Addendum #1

**T25-51 PROJECT #20251610 - PLP Classroom
Addition at Sinclair Secondary School
Closing Date: Tuesday, July 22, 2025 11:00 AM**

Picture #1 Window Location

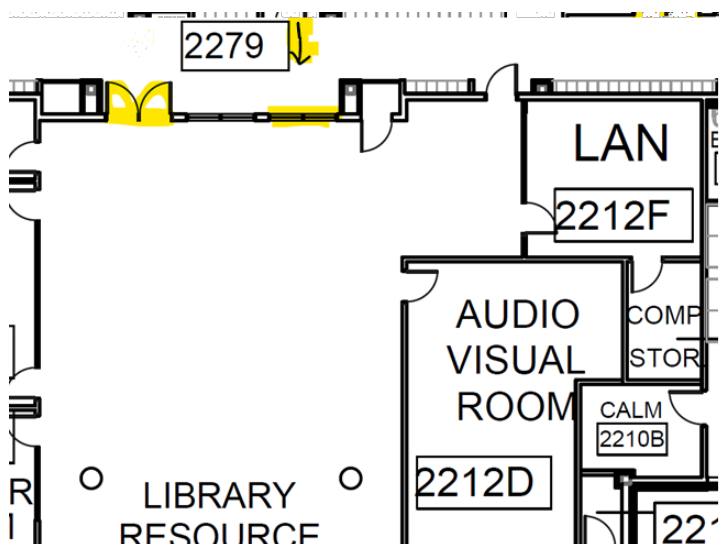
Question 4:

During the mandatory site meeting, it was mentioned that a new set of double doors is to be installed in the main library. This work was described as removing an existing window and replacing it with double doors similar in style to the current main library entry doors.

Could you please confirm whether this scope is to be included in our base bid?

Additionally, could you provide photos of the existing window where the new doors are to be installed, as well as a photo of the existing double doors you'd like us to match for our reference?

Please include following scope of work noted below in your base bid.

Work locations / pictures with the scope of work are shown below.

Picture #1 Existing Window - Remove and dispose the existing window and terrazzo tile base below the window, remove the concrete curb as required. Patch the floor with terrazzo and LVT flooring. Install a transition strip/threshold between the terrazzo and LVT. The finished work shall look like Picture #2 & Picture #3

At the window location (picture #1), the general contractor shall install a new library entry door frame, doors and hardware these materials will be supplied by the DDSB. The existing window opening will suit the new frame size. The existing G.W glazing from the window can be reuse cut the existing glazing to suit new frame and doors. The terrazzo tile wall base can be reused as required. Prime and paint the new doors.

MW001 - CONTROL PANEL

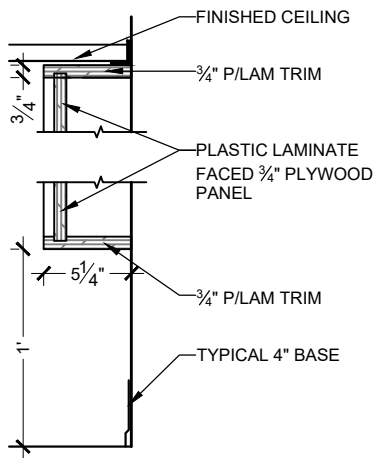
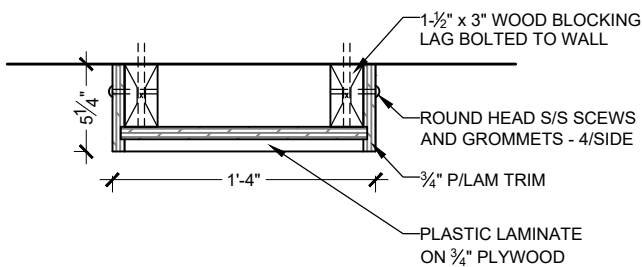
Question 1:

Provide a detail for the new custom millwork control panel Note #17

Answer 1:

Please refer to the PDF attachment – Control Panel Details
